**MONTGOMERY COUNTY HISTORIC PRESERVATION COMMISSION**  
**STAFF REPORT**

<b>Address:</b>	7107 Carroll Avenue, Takoma Park	<b>Meeting Date:</b>	2/7/2024
<b>Resource:</b>	Contributing Resource <b>Takoma Park Historic District</b>	<b>Report Date:</b>	1/31/2024
<b>Applicant:</b>	Barrett Colombo and Aimee Witteman (Richard J. Vitullo, Architect)	<b>Public Notice:</b>	1/24/2024
<b>Review:</b>	HAWP	<b>Tax Credit:</b>	Partial
		<b>Staff:</b>	Chris Berger

**Permit Number:** 1044477 REVISION

**PROPOSAL:** New fenestration, rear alterations, new patio, alterations to accessory structure, and fence removal.

Figure 5: The proposed areaway location on the right-side elevation is clouded in red.

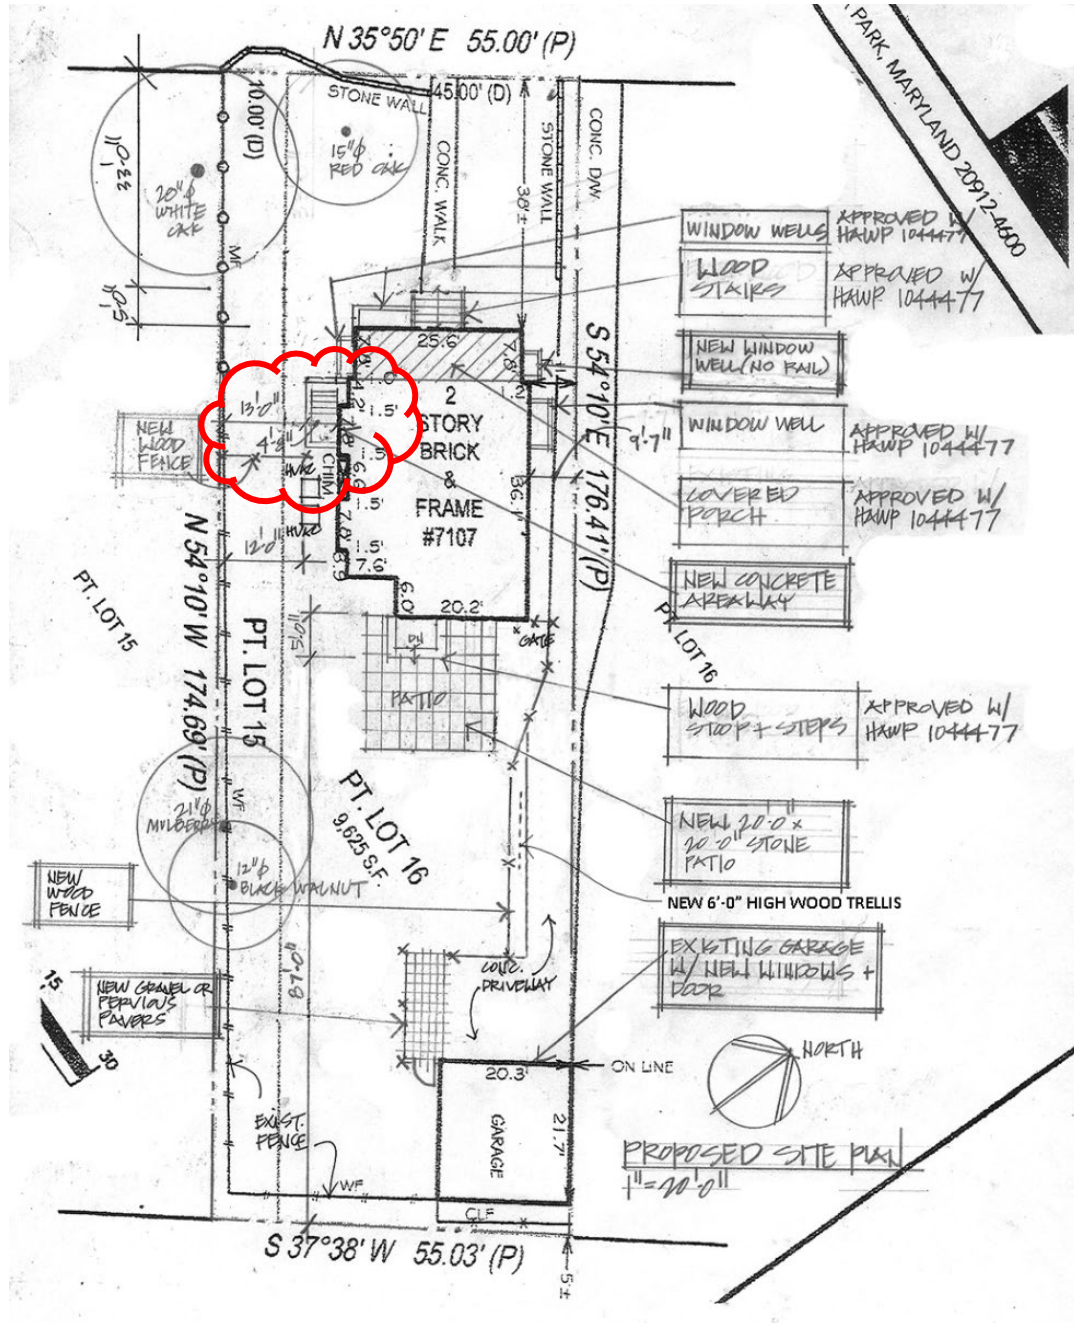
Staff is supportive of the proposal to add an accessory dwelling unit to the basement; however, staff does not support installation of the areaway in the proposed location. The HPC previously approved two new shallow window wells near on the right-side elevation under the porch and a deep well with railing on the left-side elevation, and the applicants propose another shallow well on the left-side elevation as part of this application. The proposal to add an approximately 50-square-foot areaway with railing toward the front of the house would be the largest alteration to the foundation yet.

The feature will be easily visible from the public right-of-way and, counter to the *Guidelines*, the major alteration will negatively affect the exiting streetscape, open space, and character of the property and wider district. Further, the areaway also does not meet Chapter 24A-(8)(b) and *Standards* # 2 and 9

because adding the concrete stairs and walls and metal railing in the location are not compatible with the character of the historic district and will affect the historic integrity of the property and its environment.

1. The applicants must submit specifications and final designs for each proposed window and door before the plans are stamped.
2. The applicants must submit specifications and detailed drawings for the proposed window wells and steel railings at the areaway before the plans are stamped.
3. The applicants must remove the proposed areaway and doorway from the plans before they are stamped.

Figure 7: The proposed window well on the left-side elevation is clouded in red.

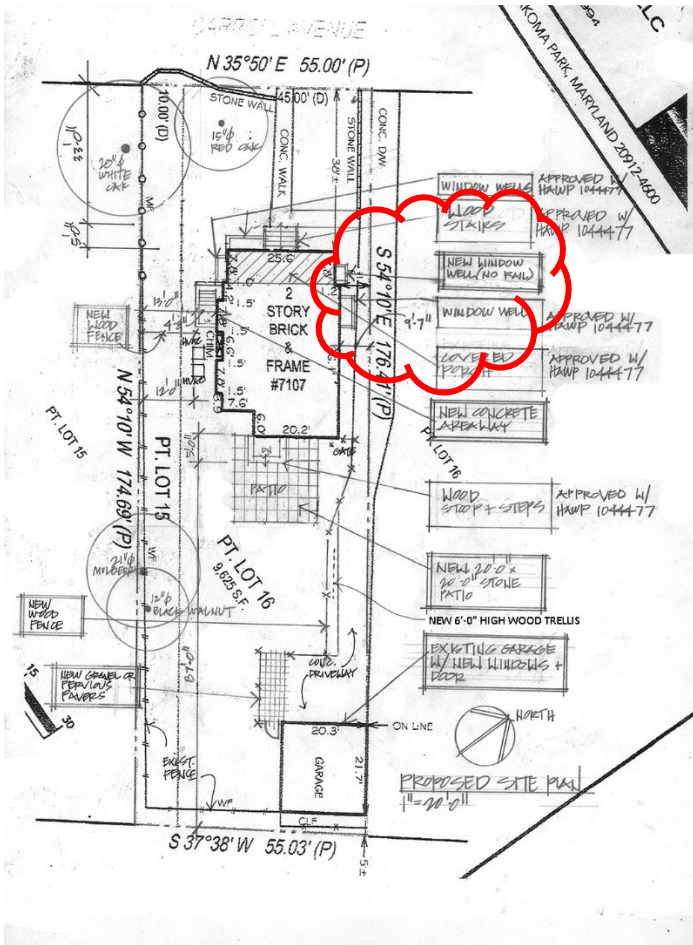
Staff finds the proposal to install a window well with a sash window on the left-side elevation to be consistent with the applicable guidelines and recommends approval with a condition. The location is a later alteration completed in the 1960s or 1970s to add additional basement space under the porch. A window currently does not exist at the location.

According to the applicants, the proposed well will measure approximately 3' wide and be no more than 1' deep, so it will not require a railing. It will have pressure-treated wood at the perimeter of the well's interior and gravel at the base. Staff reminds the HPC that a window well requiring a railing was previously approved a few feet farther back on the elevation as part of HAWP #1044477, but the well proposed as part of this application is to bring natural light into a different basement room. It will be visible from the public right of way, but most of the window will be below grade and minimally visible. The proposed window appears to be an aluminum clad 4/1 wood sash window—the same design the HPC approved on the rear elevation at its Oct. 7 HPC meeting—but staff seeks confirmation from the applicants before the plans are stamped. The applicants did not provide specifications and detailed drawings for the wells, so staff seeks a condition that information is provided.

**Figure 9: The proposed canopy on the rear.**

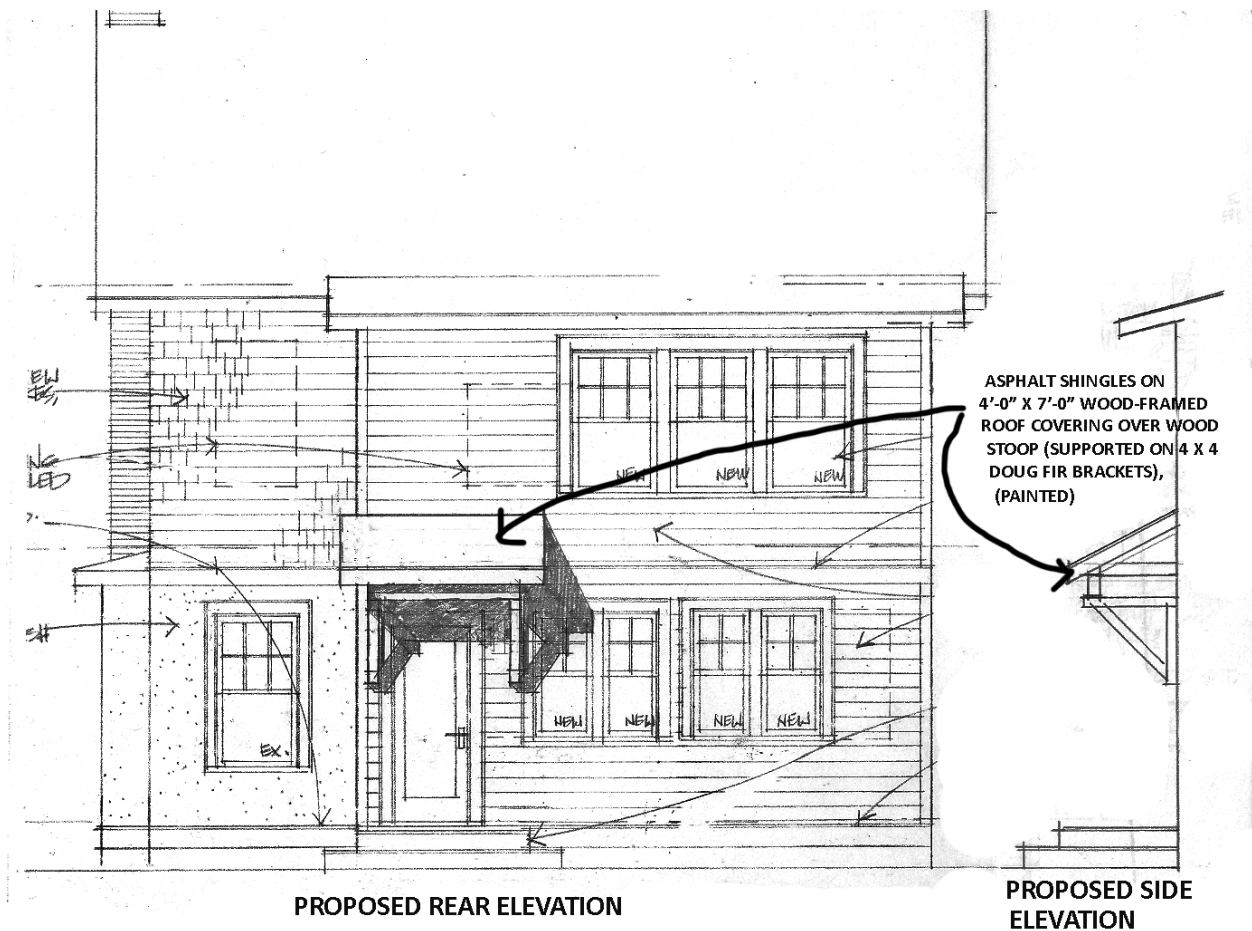
Staff finds the proposal to install a canopy over the doorway on the rear elevation to be consistent with the applicable guidelines and recommends approval. The HPC previously approved the reconfiguration of the elevation and new location of the doorway at its Oct. 7 hearing. The canopy will measure 4' by 7' and have a shed roof covered in asphalt shingles. It will be supported by 4'-by-4' Douglas Fir brackets.

The canopy will not be visible from Carroll Avenue, and the *Takoma Park Historic District Design Guidelines* are only limited to changes visible from the public right of way. In accordance with Chapter 24A-8(b)(1) and (2), the proposed canopy will not substantially alter the exterior features and is compatible with the character of the district. The proposal also meets #2, 9, and 10 of the *Standards* as the character of the property will be retained by the canopy's construction; it will not destroy historic materials that characterize a property, and if removed in the future the essential form and integrity of the property will be maintained.

Figure 10: The proposed HVAC locations are clouded in red.

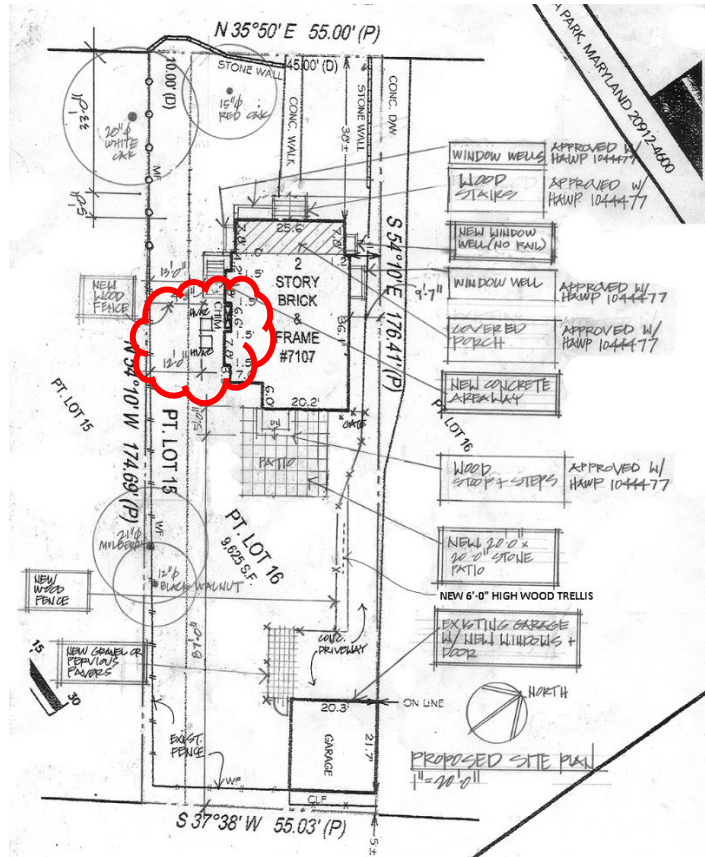
Staff finds the proposal to install a pair of HVAC units along the right-side elevation to be consistent with the applicable guidelines and recommends approval. The units will be situated toward the back of the residence, approximately 60 feet from the right of way at their closest and behind the proposed 4' tall picket fence.

The *Takoma Park Historic District Design Guidelines* state that minor alterations to areas that do not directly front a public right of way such as the installation of air conditioners should be allowed as a matter of course. In accordance with Chapter 24A-8(b)(1) and (2), the units will not alter the exterior features and are compatible with the character of the district where units are found at each residence. The proposal also meets # 2, 9, and 10 of the *Standards* as the character of the property will be maintained after installation of the units; they will not destroy historic materials that characterize a property, and if removed in the future the essential form and integrity of the property will be maintained.

Figure 11: The proposed patio location is clouded in red.

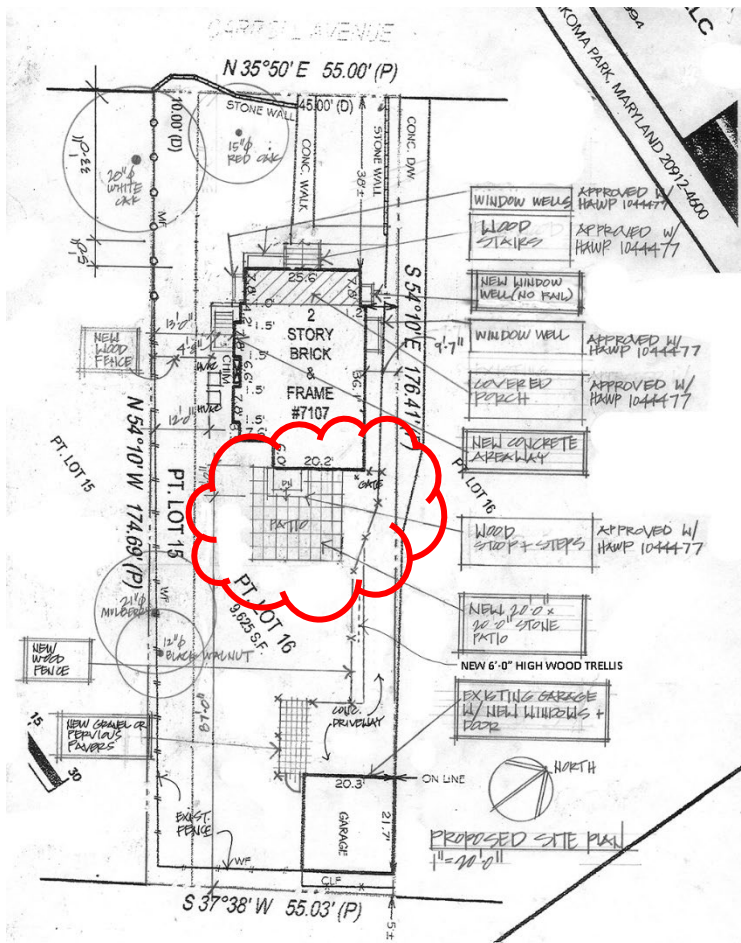
Staff finds the proposal to install a stone patio in the rear yard to be consistent with the applicable guidelines and recommends approval. The patio will be located just off the rear of the house and measure 20'-by-20'.

The patio will not be visible from Carroll Avenue, and the *Takoma Park Historic District Design Guidelines* are only limited to changes visible from the public right of way. In accordance with Chapter 24A-8(b)(1) and (2), the patio will not alter the exterior features and is compatible with the character of the district. The proposal also meets # 2, 9, and 10 of the *Standards* as the character of the property will be retained by the patio's construction; it will not destroy historic materials that characterize a property, and if removed in the future the essential form and integrity of the property will be maintained.

Figure 13: The proposed fence and trellis locations are clouded in red in the side and rear yards.

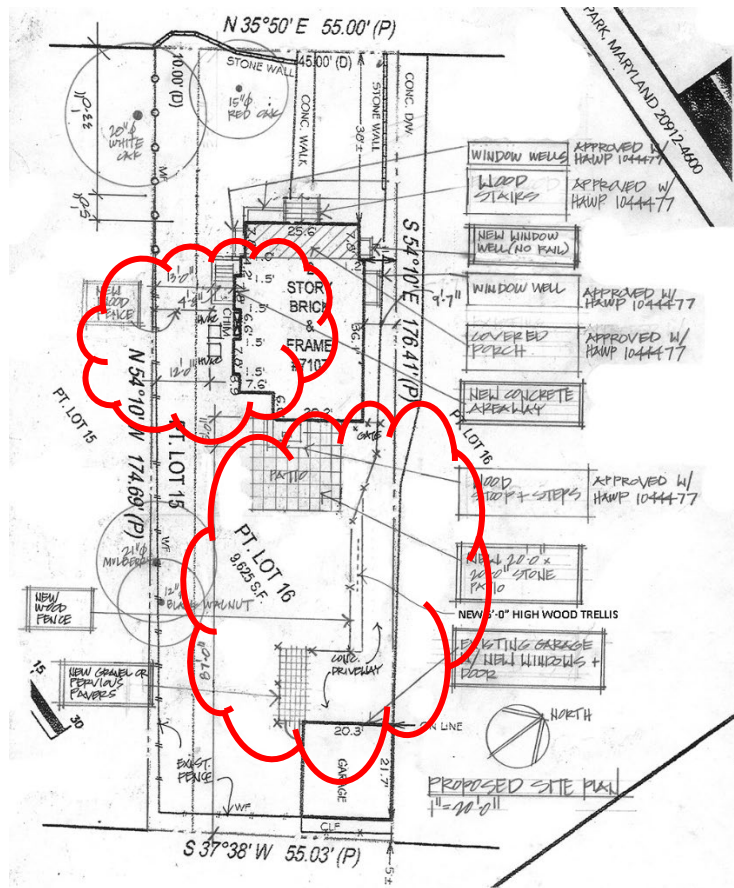
Staff finds the proposal to install fencing and a trellis in the rear and side yards to be consistent with the applicable guidelines and recommends approval. The applicants propose to install a 4' tall cedar picket fence with gates in the side yard off the left side elevation and in the rear yard along the driveway. A cedar trellis fence measuring 6' high and 10' long will be installed in the rear yard along the driveway near the proposed 4' tall picket fence. The 6' tall lattice fence that encloses a portion of the rear yard to the south of the garage will be removed.

Only the fence in the side yard will be visible from the right of way. It will have a minimal visual presence because of its open design and height and held screen the HVAC units to be installed just beyond. The *Takoma Park Historic District Design Guidelines* state that minor alterations to areas that do not directly front a public right of way such as the installation of fences should be allowed as a matter of course. In accordance with Chapter 24A-8(b)(1) and (2), the fencing will not alter the exterior features of the residence and is compatible with the character of the district where similar fences are common. The proposal also meets # 2, 9, and 10 of the *Standards* as the character of the property will be retained; the fencing will not destroy historic materials that characterize a property, and if removed in the future the essential form and integrity of the property will be maintained. Both fences meet the county's height limits.

Figure 16: The proposed elevations for the garage.

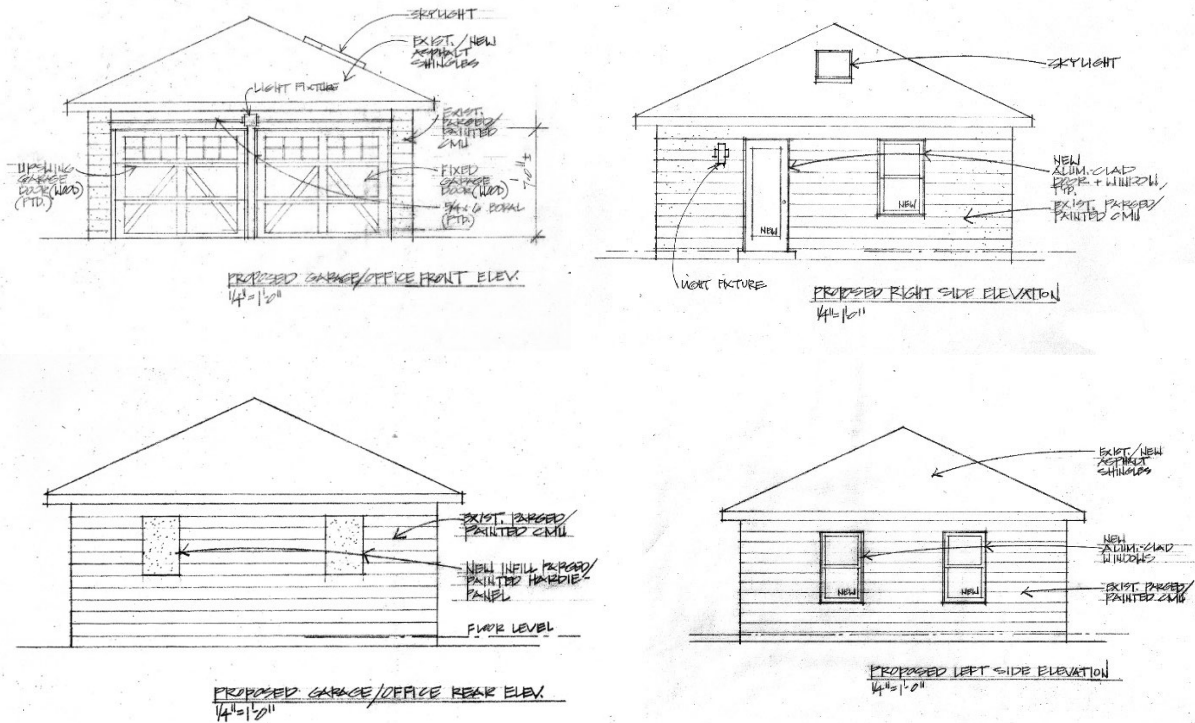
Staff finds the proposal to replace the fenestration on the garage and enclose two windows to be consistent with the applicable guidelines and recommends approval with conditions. The applicants propose to convert half the garage into an office. They propose to install two new upward-swing painted wood garage door with 12-lites garage doors on the front elevation where garage doors do not currently exist. At the right-side elevation where the office will be located, the applicants propose to replace the existing window with a 1/1 aluminum-clad wood double hung windows and replace the existing wood-paneled door with a standard-sized aluminum clad door because the existing door is too small. The applicants have not indicated which door will be installed on the provided specifications, so staff seeks a condition that this information is provided before the plans are stamped. At the rear of the garage, two existing wood casement windows will be removed, and the openings will be infilled with a Hardie panels. On the left-side elevation, the applicants propose the replacement of the existing 1/1 wood sash windows with 1/1 aluminum-clad wood sash windows. A skylight will be installed on the roof over the new office space.

Staff supports all the proposed garage alterations. Since the property is classified as a contributing resource—and not an outstanding resource—in the Takoma Park Historic District, alterations to features that are not visible from the right of way should be allowed as a matter of course. The garage itself is not mentioned in the *Takoma Park Historic District Guidelines*.

The garage is set back 150 feet from the right of way, so of the proposed changes only the garage doors will be visible from the right of way. Staff finds the garage door designs to be a contemporary take on a traditional garage door design with panels and lights toward the top and constructed of wood.

Staff supports replacement of the windows with aluminum-clad sash windows and egress door on the right-side elevation with a larger door. Staff inspected the existing windows and found them to be in poor condition, and the replacement windows will closely match the existing in compliance with the *Secretary of the Interior Standards*.

Staff finds the removal of the two casement windows on the rear elevation and infill of the openings with Hardie siding is acceptable under the guidance from the *Design Guidelines* for this accessory structure. The garage is a few feet away from the residence at 8 Columbia Avenue, so enclosing the windows will provide privacy.

Staff also is supportive of the skylight to be installed over the office. It will not affect as it will improve the functionality of the space.

Figure 17: The locations where the driveway will be reduced in size and permeable pavers or gravel added are clouded in red.

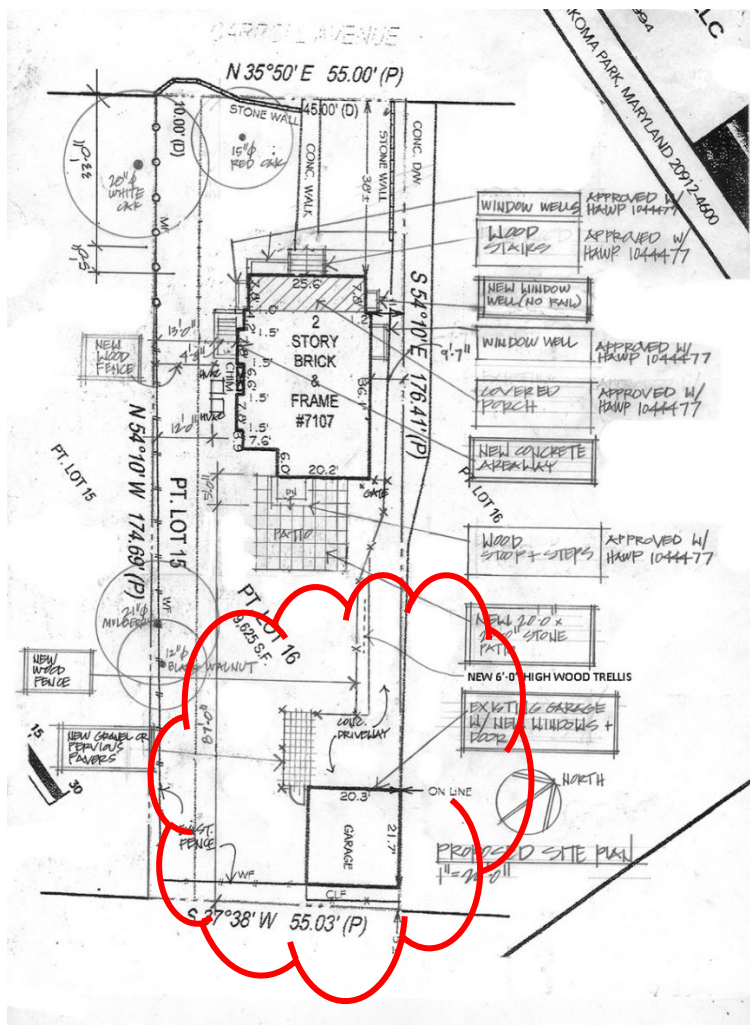
Staff finds the proposal to reduce the driveway in size and install permeable pavers or gravel to be consistent with the applicable guidelines and recommends approval. The work item will add greenspace and provide better on-site drainage.

The driveway is minimally visible from the right of way, and the *Takoma Park Historic District Design Guidelines* state that minor alterations to areas that do not directly front a public right of way should be allowed as a matter of course. In accordance with Chapter 24A-8(b)(1) and (2), the driveway alterations will not alter the exterior features of the residence and are compatible with the character of the district. The proposal also meets # 2, 9, and 10 of the *Standards* as the character of the property will be retained; the changes will not destroy historic materials that characterize the yard, and if removed in the future the essential form and integrity of the yard will be maintained.
